WCAP-16793-NP, Rev.0 (Non-Proprietary)
Project No. 694

March 2, 2009

OG-09-84

Subject: Pressurized Water Reactor Owners Group
Responses to the NRC Request for Additional Information (RAI) on WCAP-16793-NP, "Evaluation of Long-Term Cooling Considering Particulate, Fibrous and Chemical Debris in the Recirculating Fluid" (PA-SEE-0312)

Figure 22: Integrated Core Flow vs. Core Boil-off for Uniform $C_D = 100,000$ Case

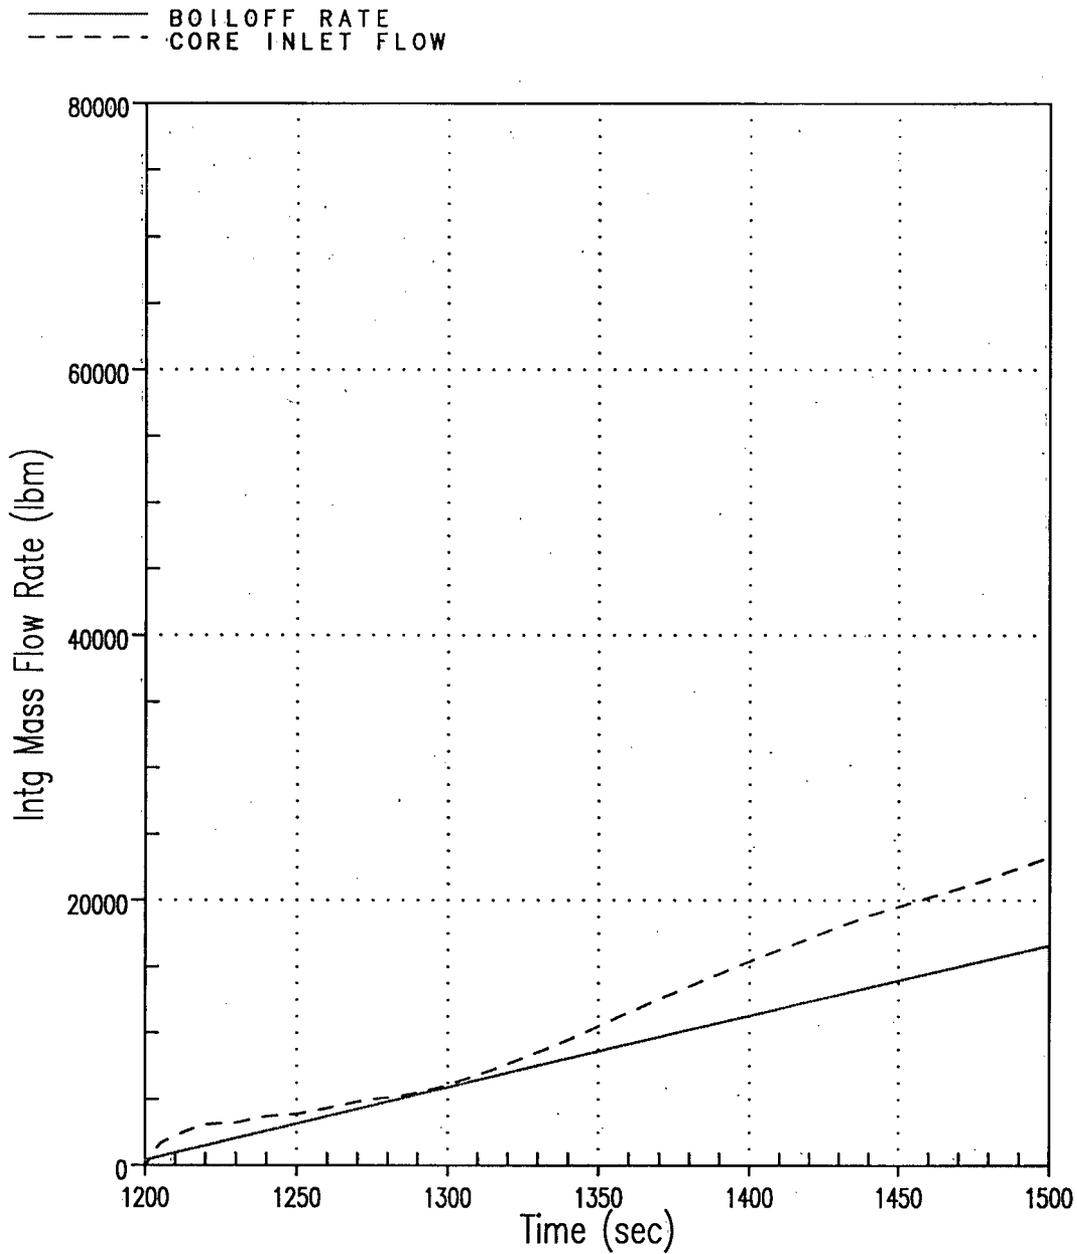
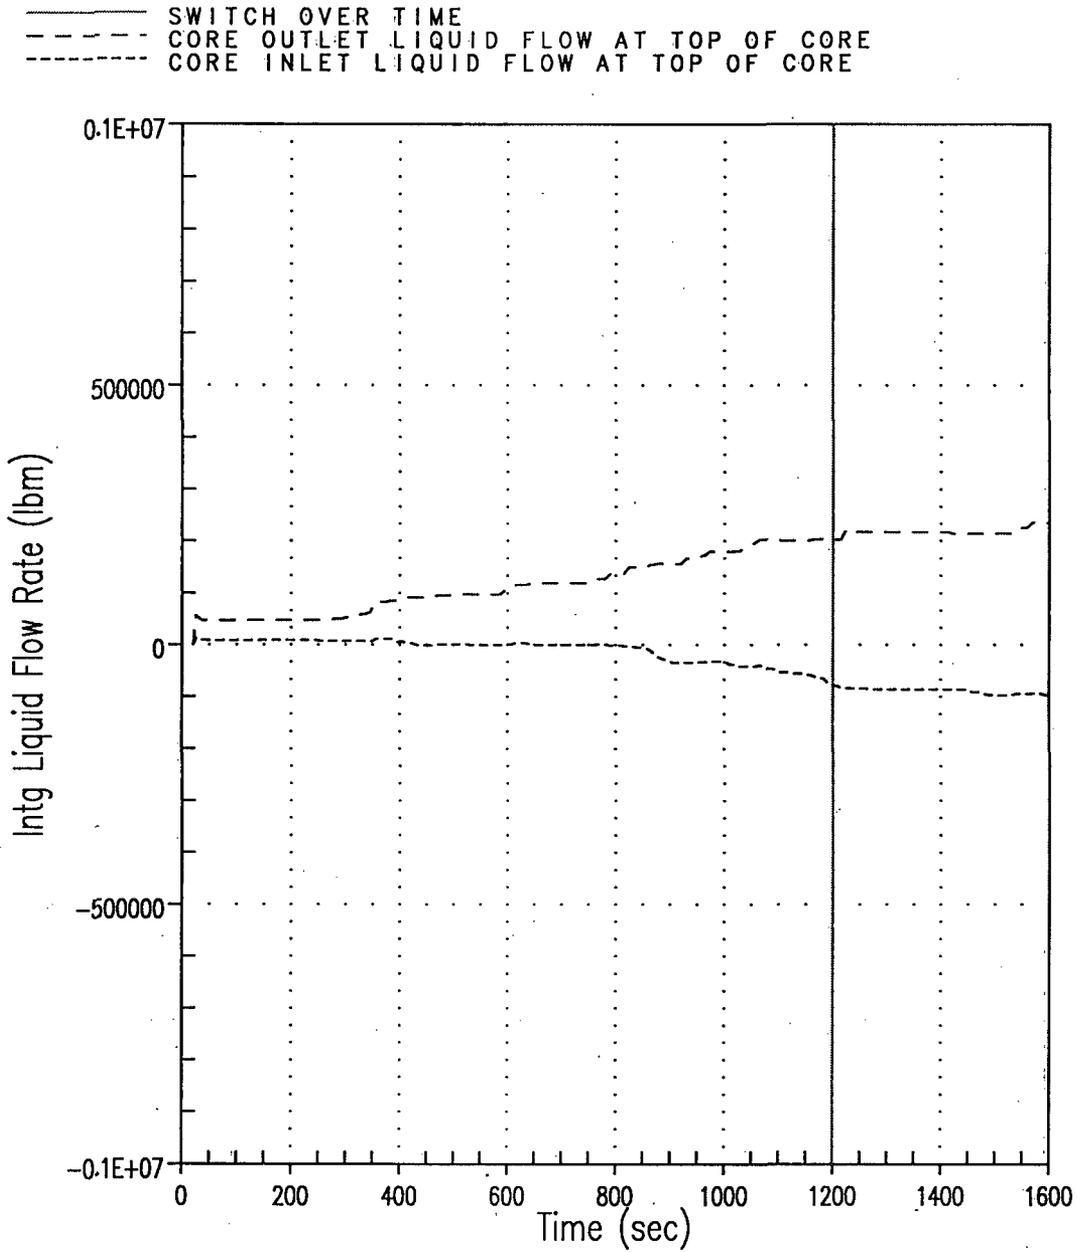
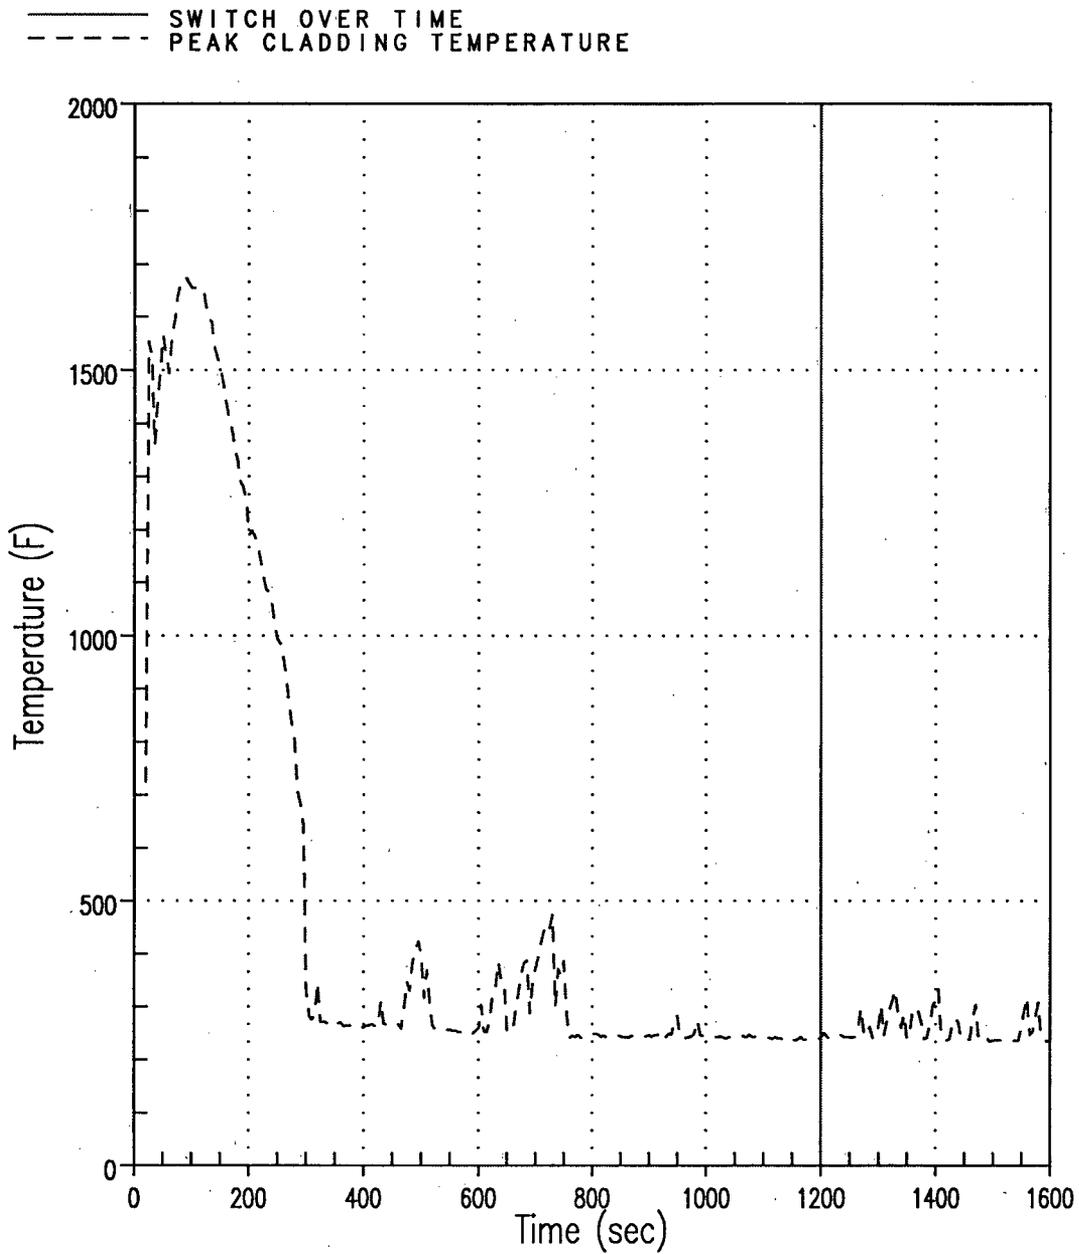
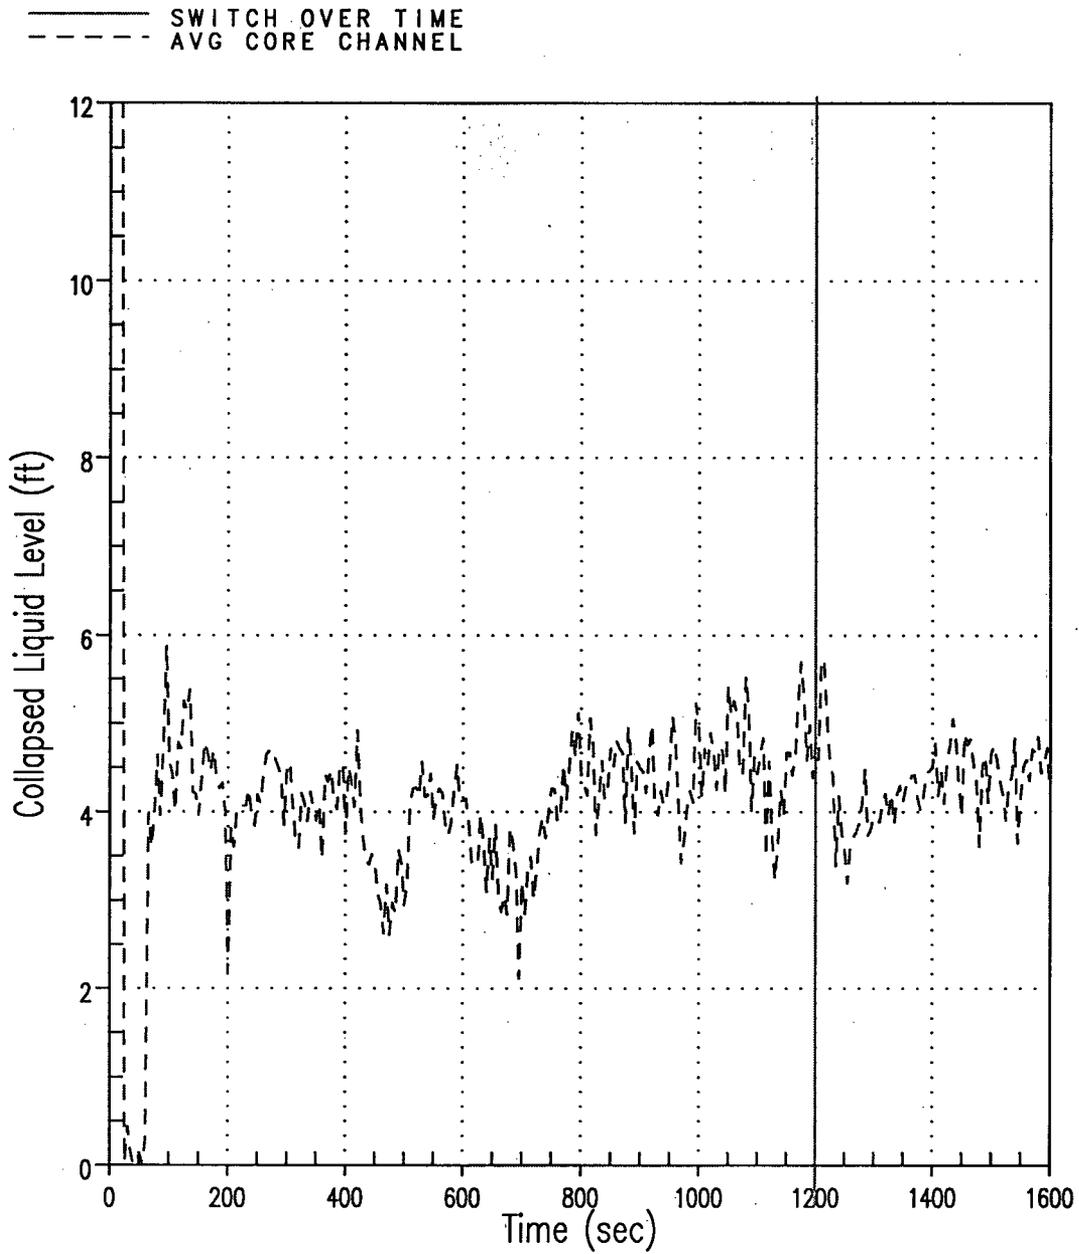
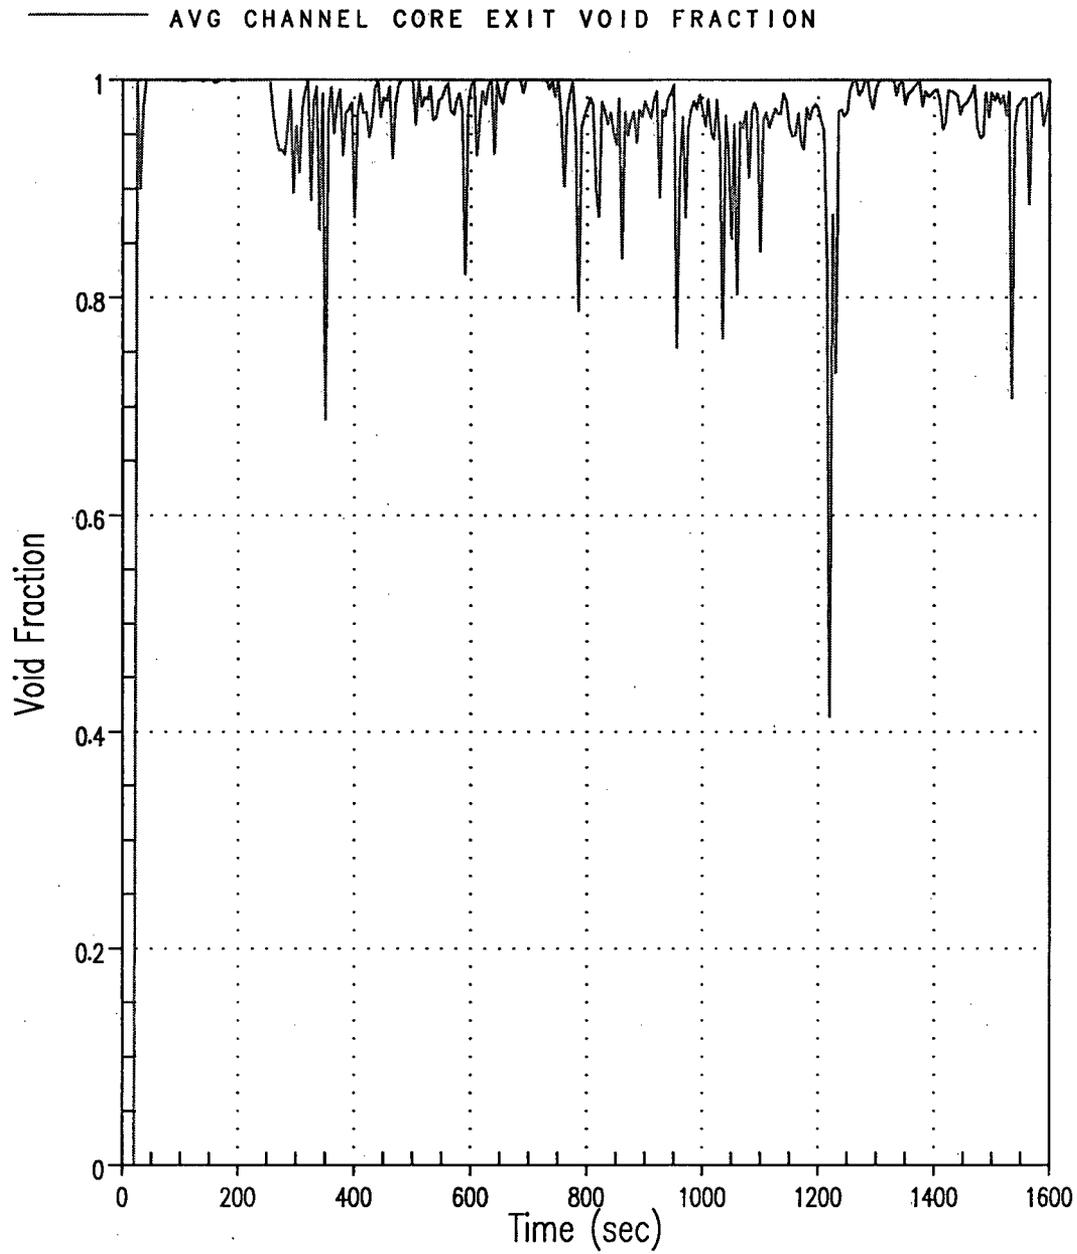
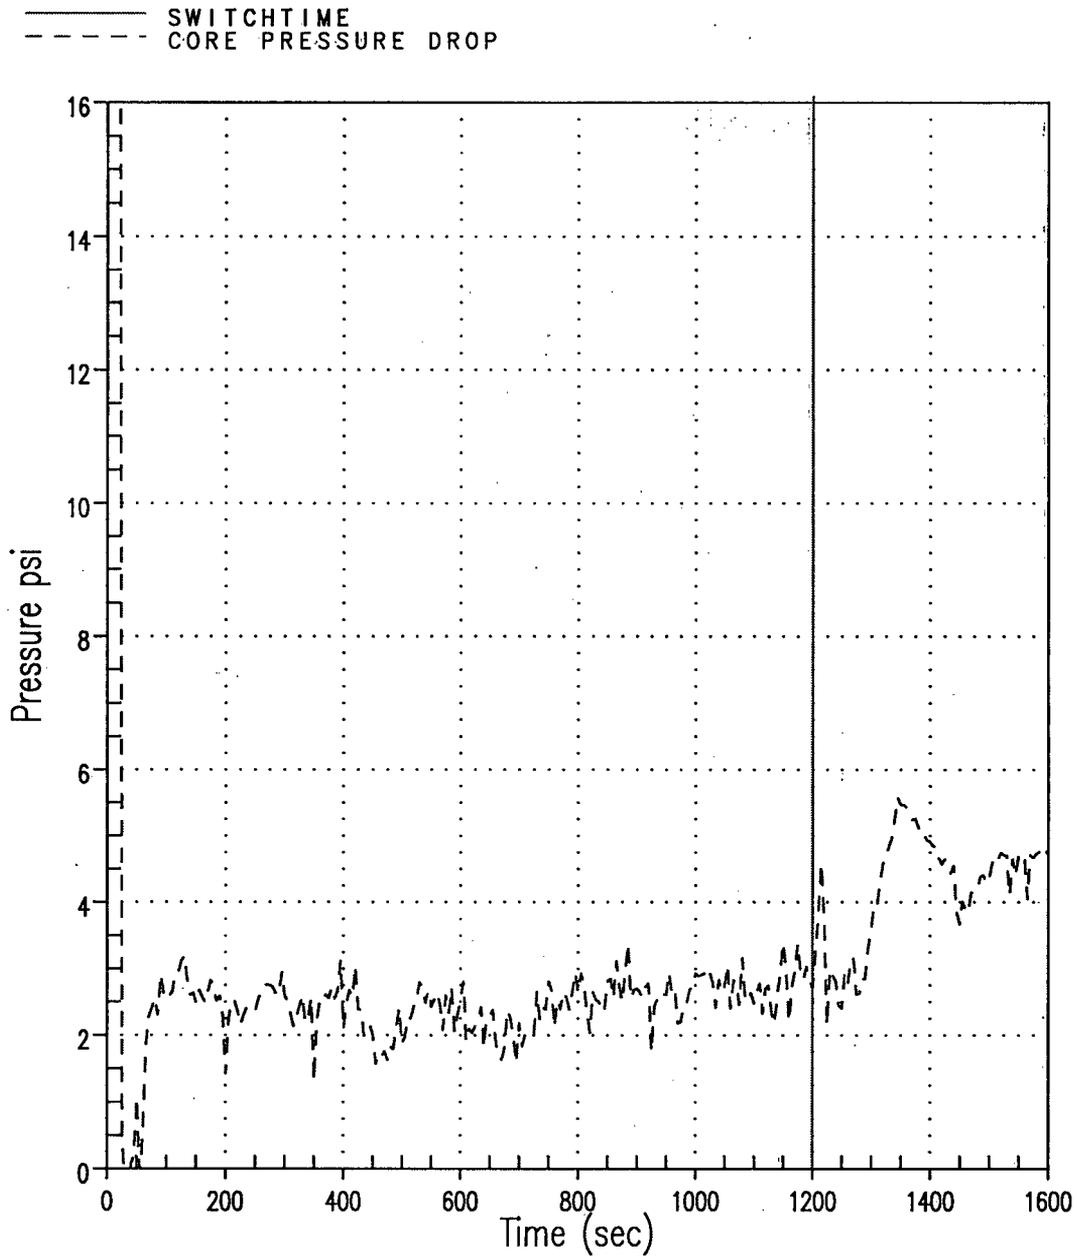
- 1) WCAP-16793-NP, Appendix B, presents analyses of the effect of core inlet blockage using the WCOBRA/TRAC analysis code. Since the report was prepared additional analyses have been performed to determine the blockage level that would reduce core flow below that necessary to match coolant boil-off. Please provide documentation of the additional analyses that have been performed, including figures, for the integrated core inlet and exit flow, peak cladding temperature, core collapsed liquid level, core exit void fraction, and core pressure drop for the bounding conditions. The results should be presented for each case analyzed up to and including the blockage level for which boiloff is no longer satisfied.

The second uniform loss coefficient run performed applied a uniform C_D of 100,000 at the core inlet. The requested plots for this case are shown in Figures 22 through 28. Figures 22 and 23 show comparisons of the integrated core inlet flow and boil-off rate. As shown, even with the further increase of the loss coefficient at the inlet, the flow that enters the core is still in excess of the boil-off rate. (Note that the integrated mass flow rate of Figure 23 shows a similar behavior as was shown in Figure 16. Again, this is due to the 30 second ramp-up of the hydraulic loss coefficient, C_D , to 100,000 that is initiated in the calculations at time $t = 1200$ seconds, but extends the behavior over a slightly longer period of time.) Figure 24 displays the integrated liquid flow at the core exit. The figure displays that liquid in excess of that needed to keep the core quenched enters the core and that some liquid flow is still present at the top of the core even after the increase of the loss coefficient at the inlet. The PCT is shown in Figure 25. There are no significant PCT excursions after the core inlet loss coefficient is increased. Figure 26 displays the collapsed liquid level of the average assembly core channel (Channel 11 of Figure 6.3.4-3 in Reference 1). The figure shows that the collapsed liquid level drops slightly at time blockage occurs, however, the liquid level recovers even after the increase in the loss coefficient at the inlet. The void fraction at the core exit shown in Figure 27 again illustrates that liquid is present at the top of the core which shows the flow that enters the core after the increase of the loss coefficient occurs is still in excess of the boil-off rate. The core pressure drop is displayed in Figure 28. The figure displays an increased pressure drop of roughly 2 psi as blockage at the core inlet is increased. As the conditions in the Reactor
